From the Vancouver Fraser Port Authority re: Requirements for Information Pertaining to Changes to the Roberts Bank Terminal 2 Project

ROBERTS BANK TERMINAL 2 PROJECT

Project Construction Update

FIG No.
4-5

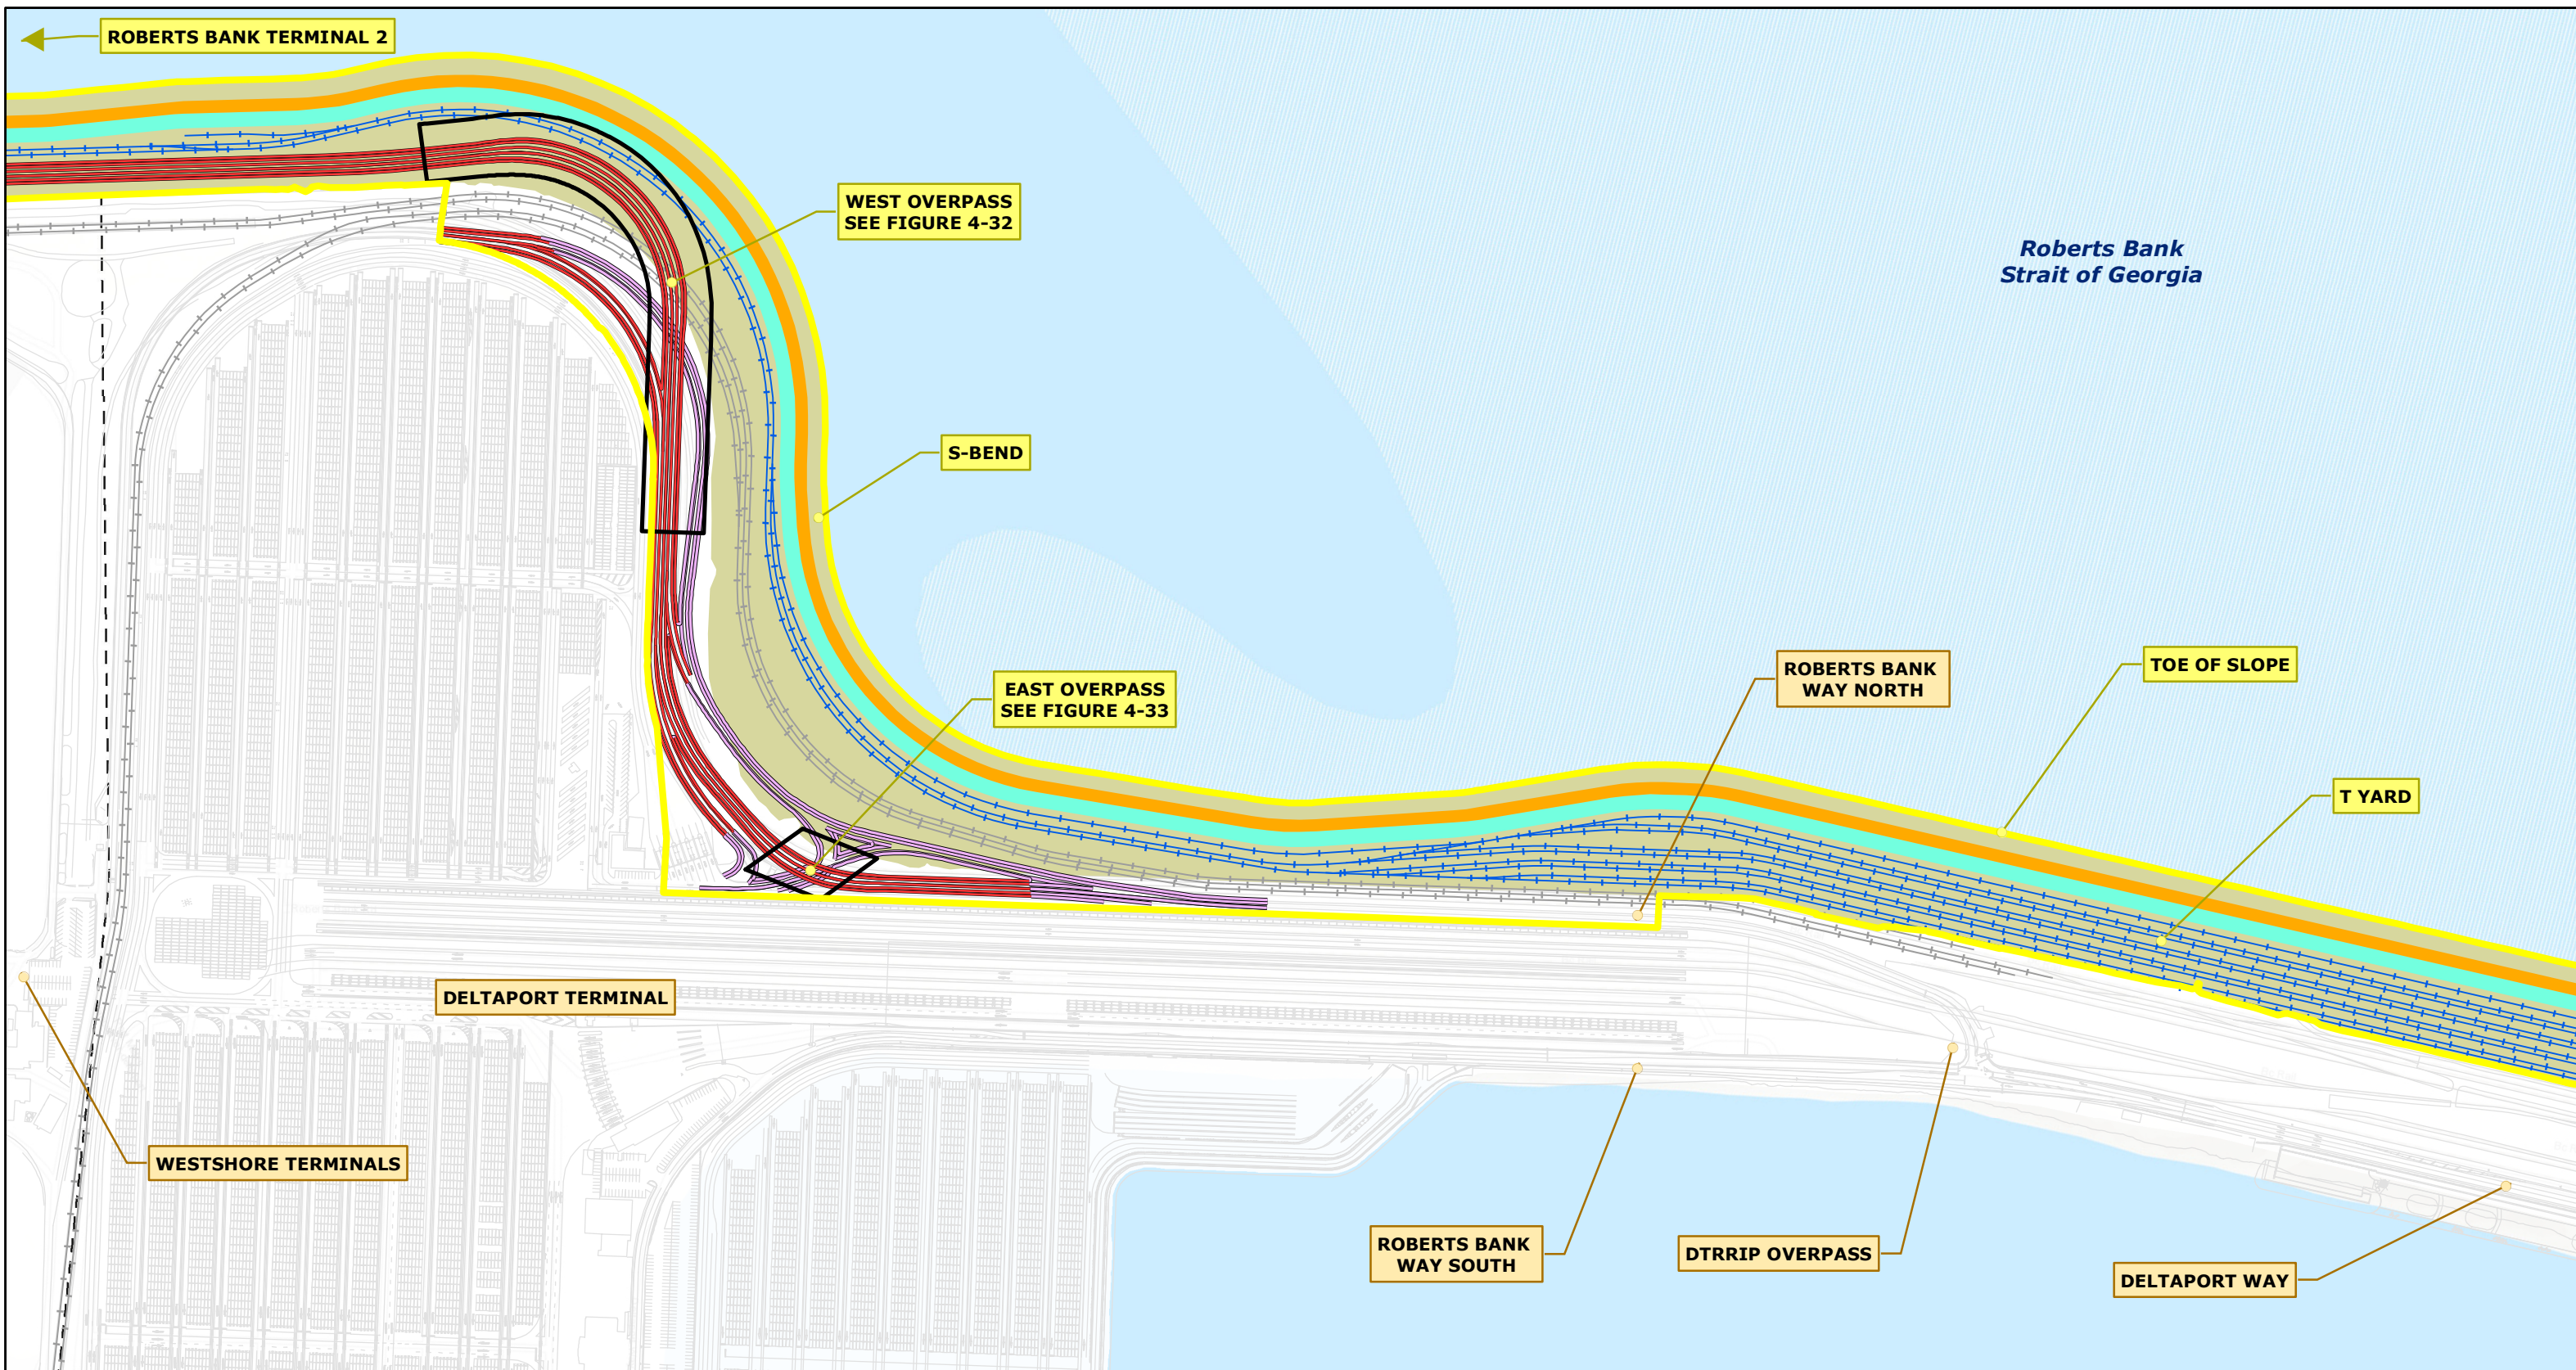
trench dredge prism slopes have also been flattened (i.e., less steep) from the original Project preliminary design (1.5H:1V shown in EIS Figure 4-5) to 2.25H:1V on the seaward side and 2.5H:1V on the shoreward side, as shown in **Attachment A**, Updated Figure 4-5. These slope changes were made to improve the constructability and stability of the dredge prism slopes, thereby eliminating the need for buttress mattress rock on the shoreward side.

Place buttress rock and sacrificial stone	4,000	m ³ /d	Bottom dump scow, trimming by 2 clams	Based on the 2016 Supplemental Geotechnical Investigation, the updated EIS reference Figure 4-5 Cross Section of Caisson Wharf Structure removes the requirement of sacrificial stone. Also, slope support (buttress rock) is not required since the dredged slopes have been revised to be flatter.
	Remove sacrificial rock	2,000	m ³ /d	By clam to barge, trimming by 3 clams	Based on the 2016 Supplemental Geotechnical Investigation, the updated EIS reference Figure 4-5 Cross Section of Caisson Wharf Structure removes the requirement of sacrificial rock.
	Place mattress rock and overbuild	6,000	m ³ /d	Bottom dump barge, trimming by 3 clams	Based on the 2016 Supplemental Geotechnical Investigation, the updated EIS reference Figure 4-5 Cross Section of Caisson Wharf Structure removes the requirement of mattress rock overbuild.

Densify mattress rock and sand fill	1,000	m ³ /d/rig	6 rigs in 2 fronts used	Based on the 2016 Supplemental Geotechnical Investigation, the updated EIS reference Figure 4-5 Cross Section of Caisson Wharf Structure has added sand fill to be densified.
	Remove mattress rock overbuild	2,000	m ³ /d/rig	By clam, 2 rigs used	Based on the 2016 Supplemental Geotechnical Investigation, the updated EIS reference Figure 4-5 Cross Section of Caisson Wharf Structure removes the requirement of mattress rock overbuild.
	Place and screed levelling course	100	m ² /d		
	Construct concrete caissons	1	#/wk		
	Place Caisson Ballast	4,000	m ³ /d	1-5000 t barge/day placed by 2 clams	
	Place Rock Berm	4,000	m ³ /d	Bottom dump barges, trimming by 2 clams	
	Place Berm Filter	2,000	m ³ /d	Bottom dump barges, trimming by clam	
	Place Scour Protection	800	m ³ /d	By clam	
H	Wharf Construction - land operations				
	Apron area soil densification	1,500	m ³ /d/rig	3 rigs used
